# Access Compliance Report

## Public Rights-of-Way

Intersection ID: 17974	Main Street: OLD_PINEVILLE_RD	Cross Street: SPRINGBROOK_RD	Location: NW
ADA ID: 1796791662D6	Ramp Type: Directional1	Initial Pass/Fail: Fail	Overall Compliance: No
		Severity Score: 1.25

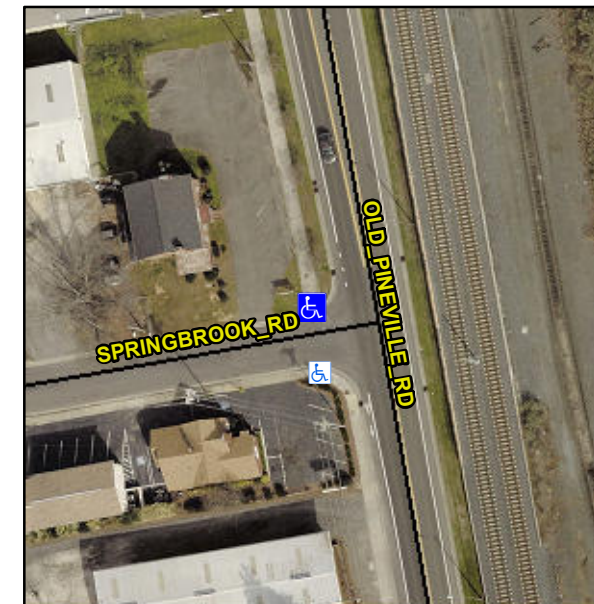
**R304.5.3**

Compliance	Description	Data	Compliance	Description	Data
N/A	Ramp Length (in)	73.0	N/A	Grade Break?	N/A
Yes	Ramp Width (in)	92.0	N/A	Grade Break Slope (%)	0.0
Yes	Ramp Slope (%)	1.1	N/A	Grade Break XSlope (%)	0.0
No	Ramp XSlope (%)	3.2			
N/A	Flare Type LT	N/A	N/A	Flare Type RT	N/A
N/A	Flare Slope LT (%)	N/A	N/A	Flare Slope RT (%)	0.0
N/A	Flare Traversable LT?	N/A	N/A	Flare Traversable RT?	N/A
N/A	Landing Length (in)	0.0	N/A	DWS Provided?	N/A
N/A	Landing Width (in)	0.0	N/A	DWS Contrast?	N/A
N/A	Landing Slope (%)	0.0	N/A	DWS Length (in)	N/A
N/A	Landing X Slope (%)	0.0	N/A	DWS Full Width?	N/A
N/A	Landing Curb? (Y/N)	N/A	N/A	DWS Offset LT (in)	N/A
N/A	Shared Landing?	N/A	N/A	DWS Offset RT (in)	N/A
N/A	Gutter Ponding?	0.0	N/A	Gutter Slope (%)	N/A
N/A	Gutter Lip Ht (in)	0.0	N/A	Gutter X Slope (%)	N/A
N/A	Painted X Walk1?	No		Road Slope (%)	2.4
	X Walk 1 Direction	To S		Road X Slope (%)	3.8
	X Walk 1 Width (in)	N/A		Clear Space?	N/A

**Remove & Replace Entire Ramp.**
